FACILITY: Midland Plant, Units 1 and 2

SUBJECT: SUMMARY OF JULY 27 - 30, 1982, AUDIT ON
SOILS REMEDIAL ACTIVITIES

Table 2.5-14
(sheet 1)
Revision 44
6/82

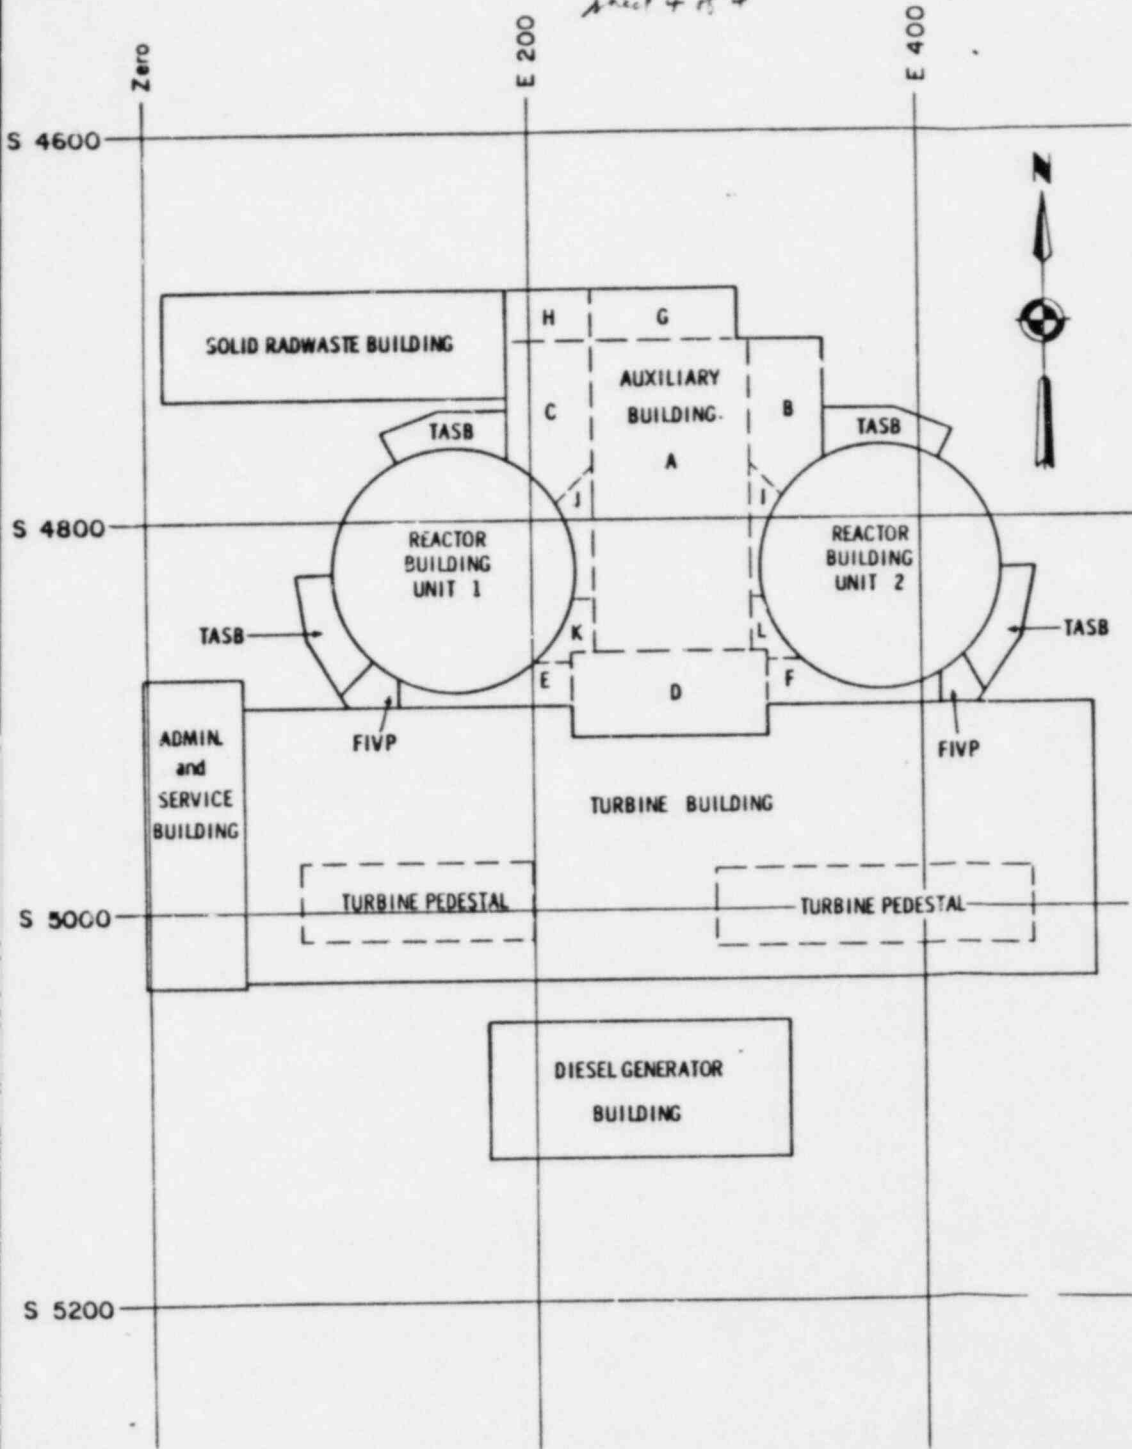
A draft of FSAR Table 2.5-14, including bearing pressure data for the Auxiliary Building (AB), was provided (Attachment 1). The staff reviewed the table, noted that the information was acceptable and that once provided for the docket and verified, this item would be technically closed.

Consider change to comparison w/gross

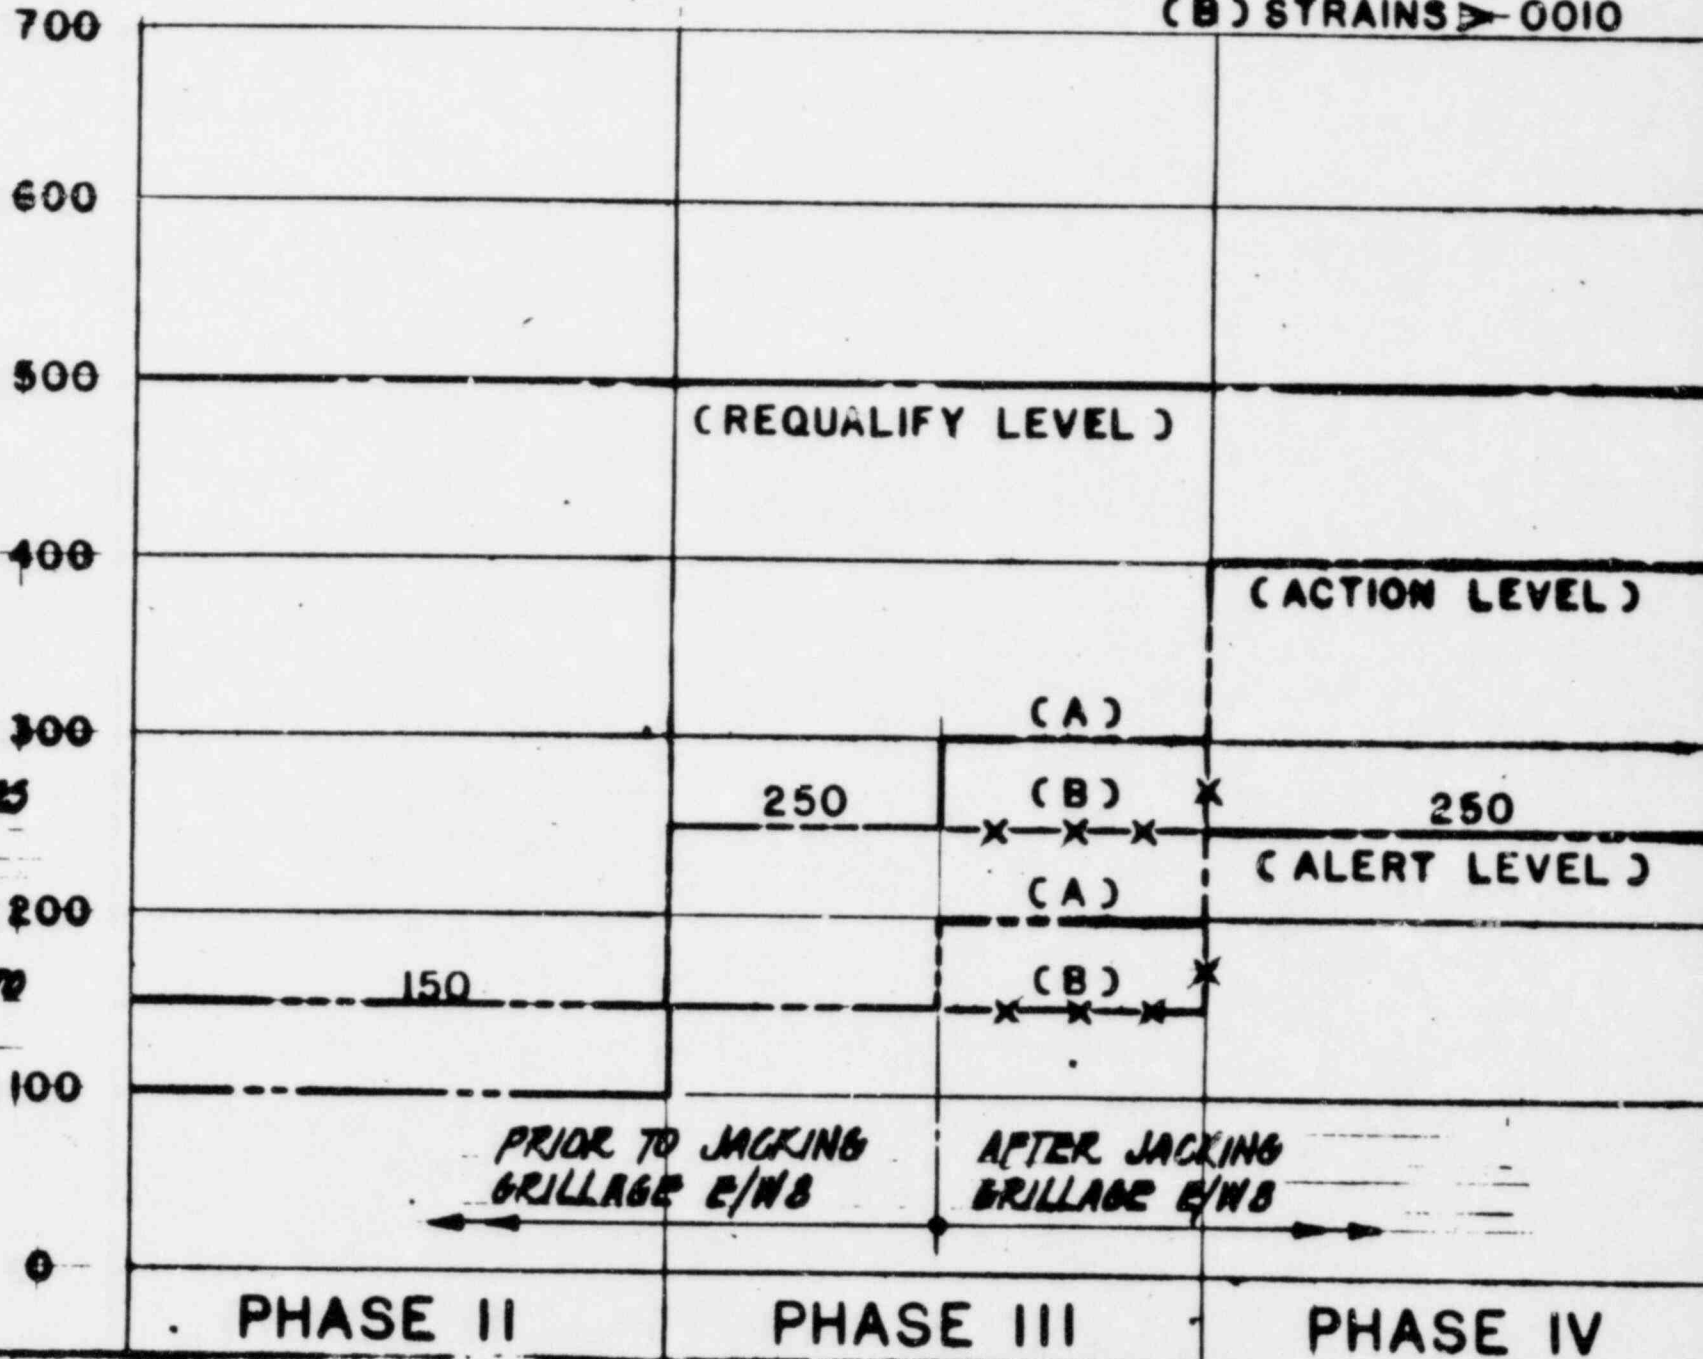
Attachment 2 provides definitions of "alert", "action" and "requalify" levels which were agreed upon for underpinning activities. Attachment 3 provides numerical values which were agreed upon. The levels apply to Phases II, III, and IV.

Once the alert level is exceeded, the site resident engineer must inform engineering in Ann Arbor of the situation. The data including information from the other appropriate data mechanisms should be evaluated in total. Where trends exist that indicate the action level is likely to be reached, plans should be evaluated to remedy the situation. (Note: It is recognized that the evaluation may well conclude that no changes are warranted.)

and actions described in Specification C-200
Plans, should be initiated to modify the condition that caused the
settlement reading to ^{reach} ~~exceed~~ the action level. Consumers Power Company
must be informed of the revised plan so that the NRC can be advised of
the situation. The revised plan shall be initiated immediately upon
verbal notification by the resident structural engineer. ~~(Note: It is
recognized that the evaluation may well conclude that no changes are
warranted.)~~ If continuous movement beyond action level occurs, immediate
~~action shall be taken per Specification C-200.~~

If the differential settlements reach 0.50 inch, ^(Requality level) the applicant will start
discussions with NRC for consideration of and concurrence with future
actions before implementing those actions.

Figure 1

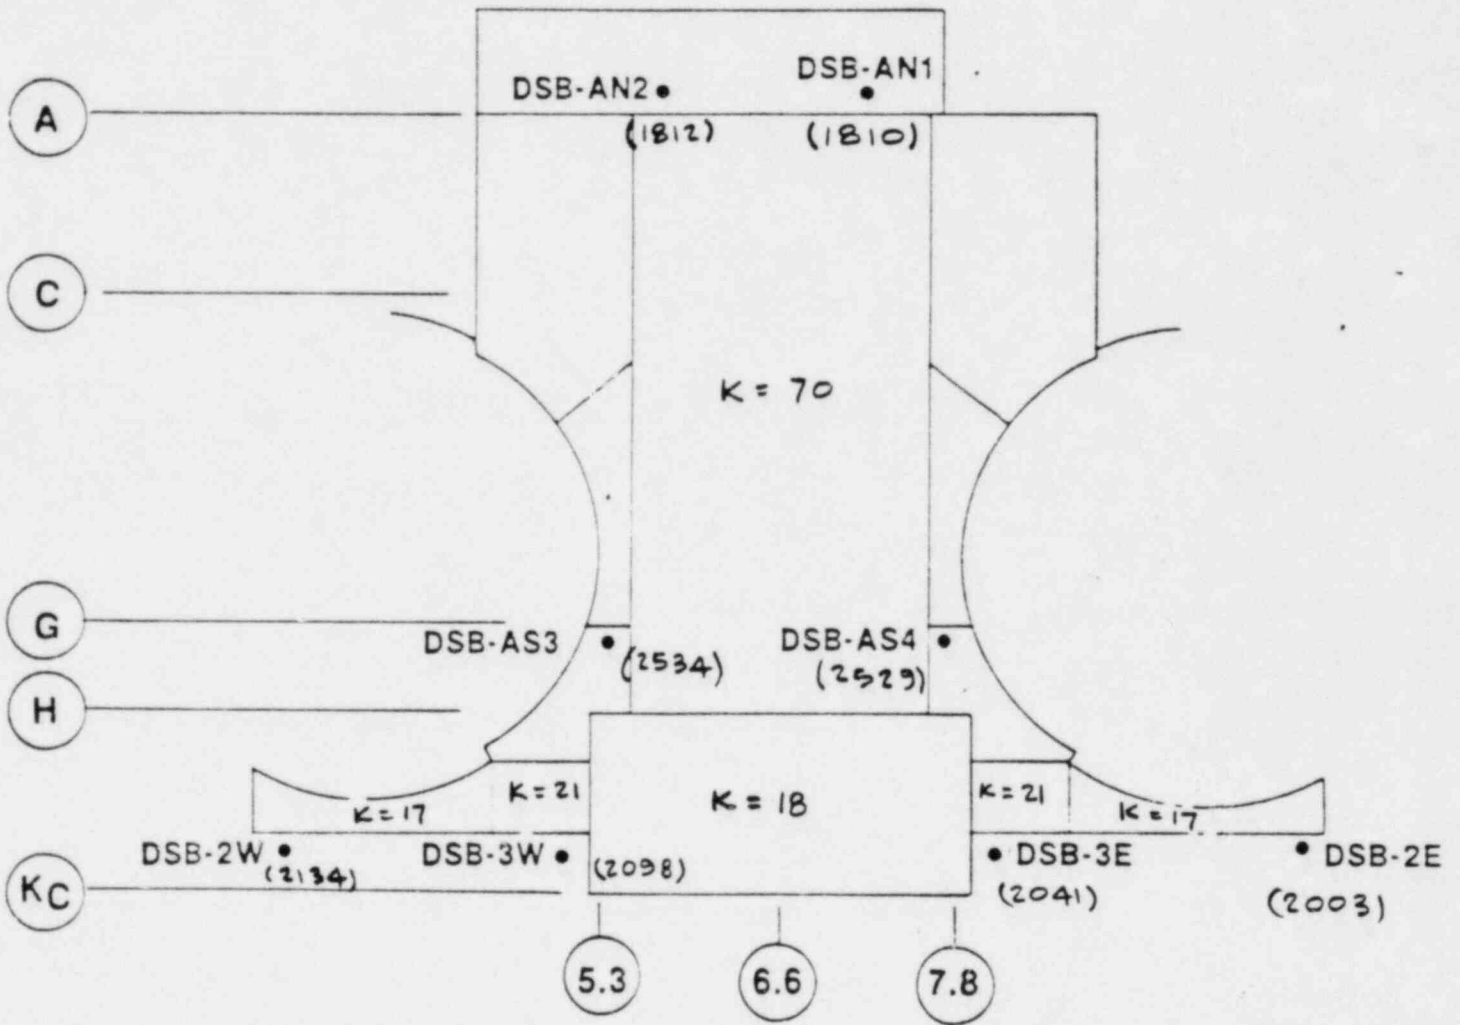
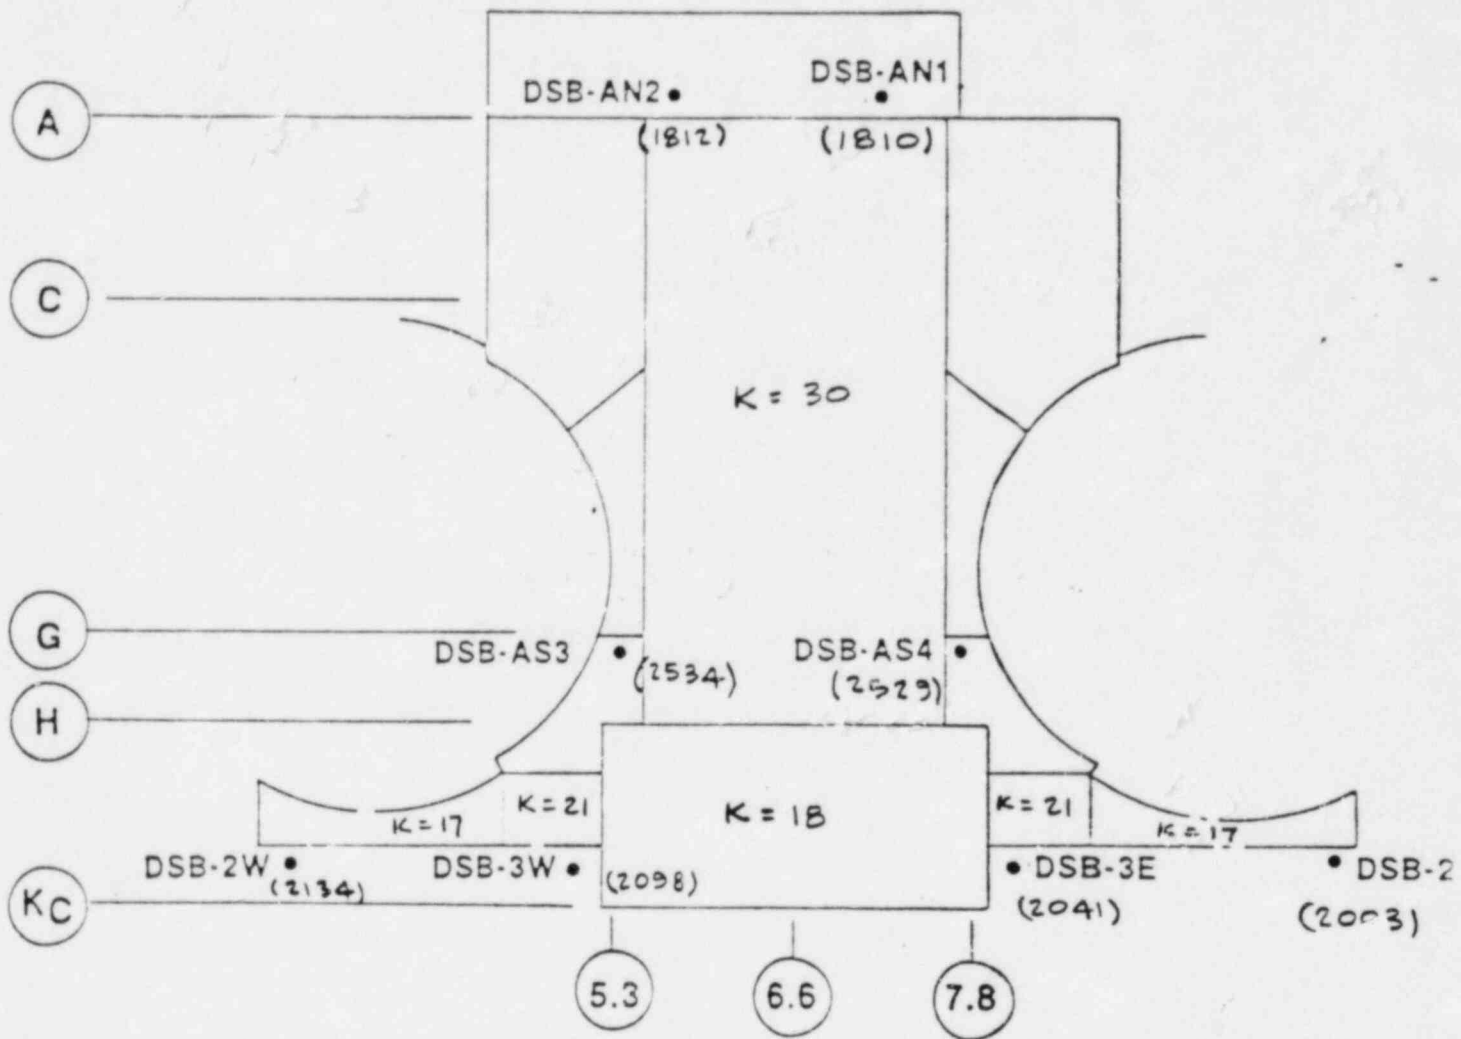
The NRC staff reviewed the allowable settlement calculation resulting from analysis of the construction condition using a subgrade modules of 70 KCF and analysis of reduced support along the EPA due to tunneling (Attachment 4).

Attachment 7

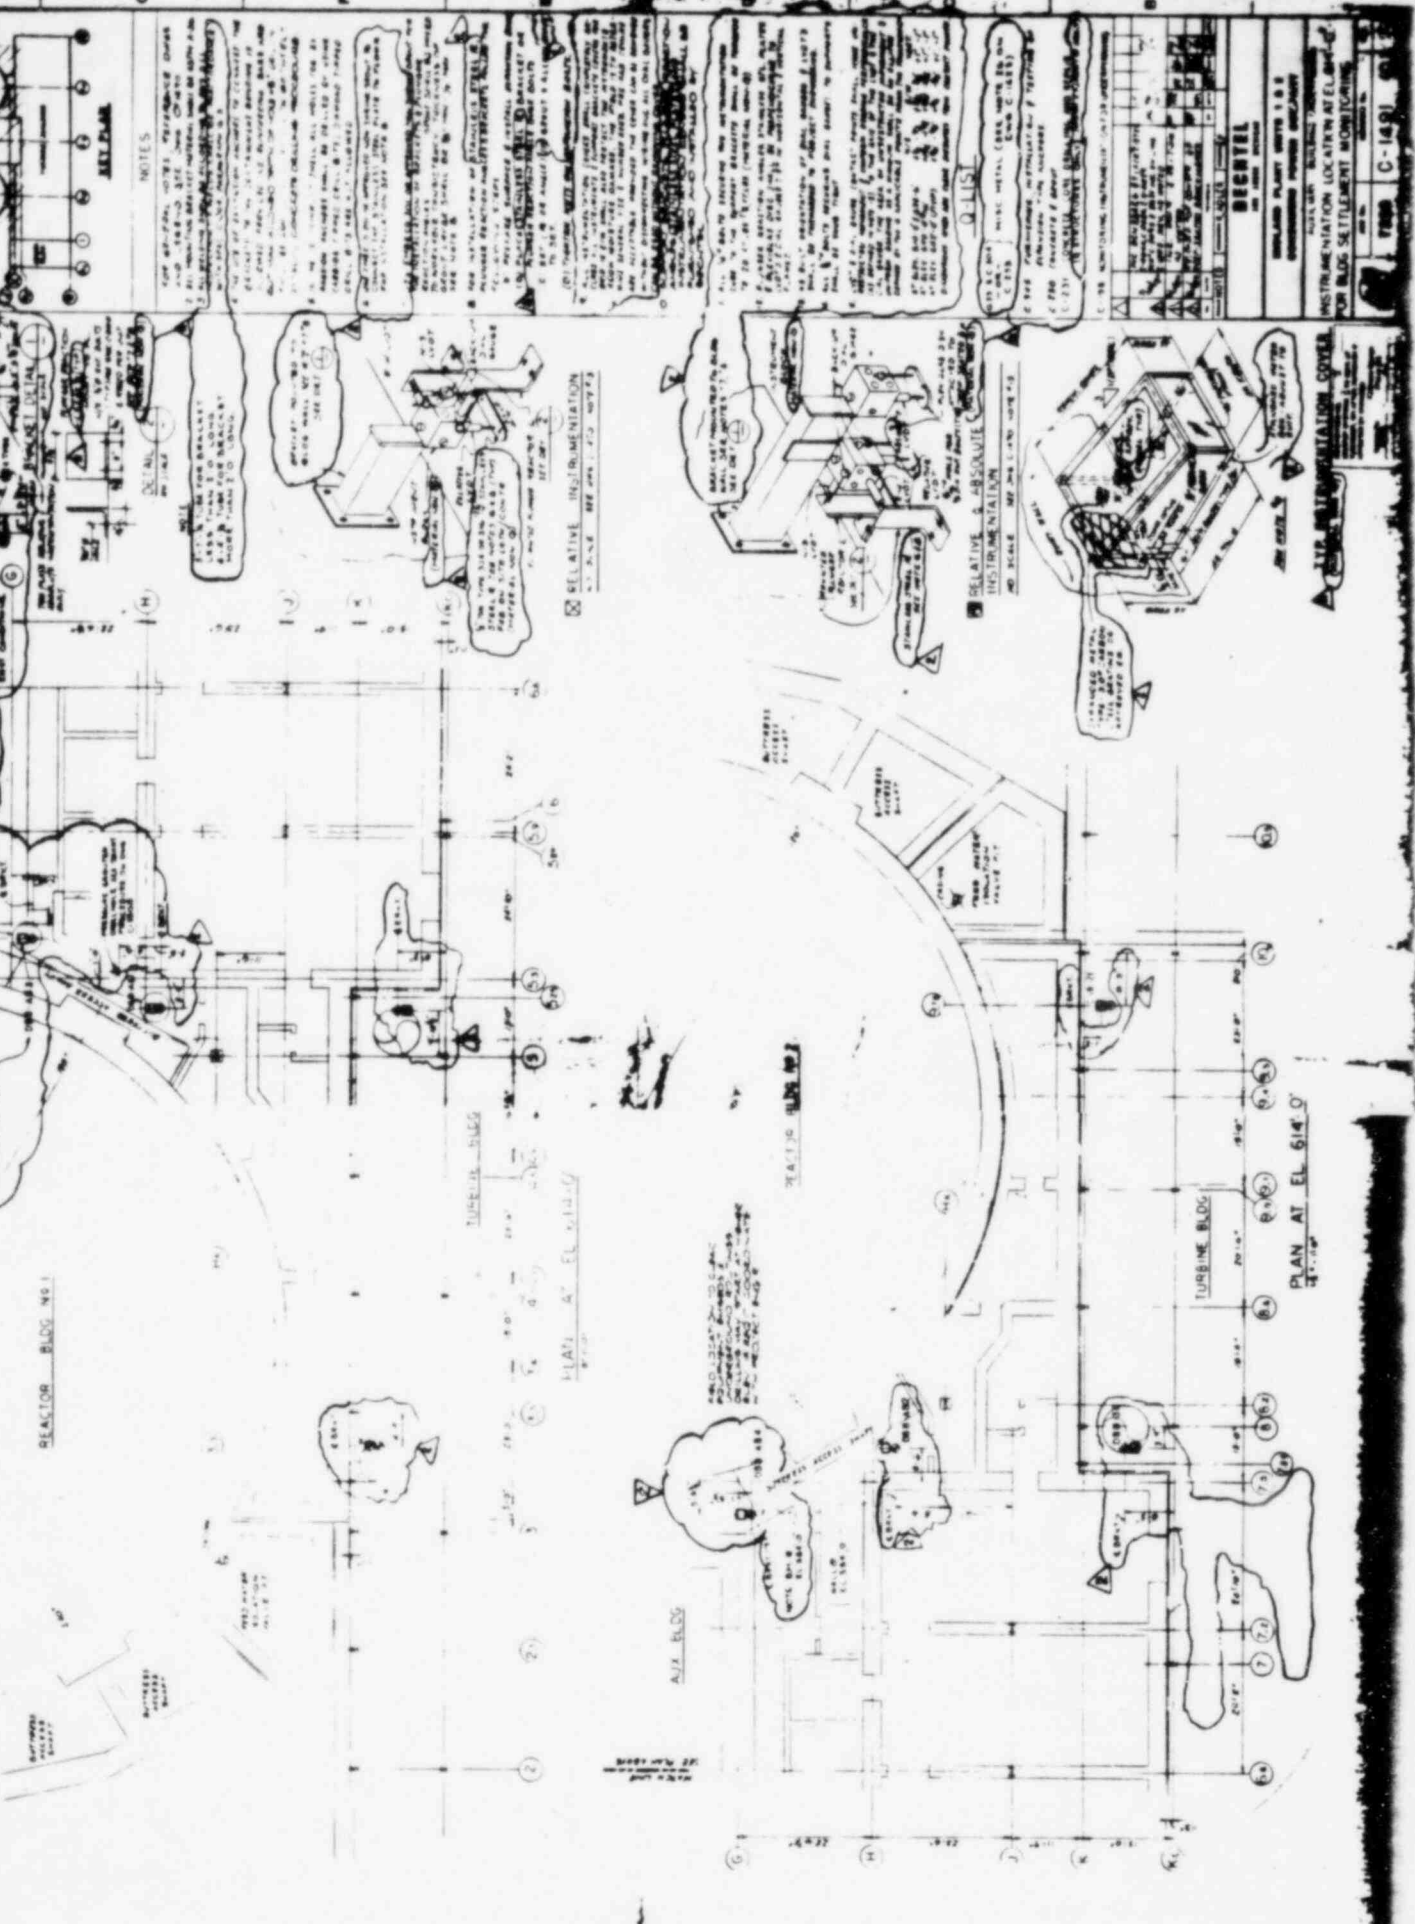
An updated copy of the monitoring matrix (Bechtel Drawing 7220 C-1493(Q), Rev. 1) (Attachment 7) was provided. Alert, action and requalify levels will be added as agreed above (AB Item 1).

The NRC staff reviewed Bechtel Drawings 7220-C-1490 and C-1491 (Attachment 7) showing as-built locations of the AB deep-seated benchmarks and found them to be technically acceptable.
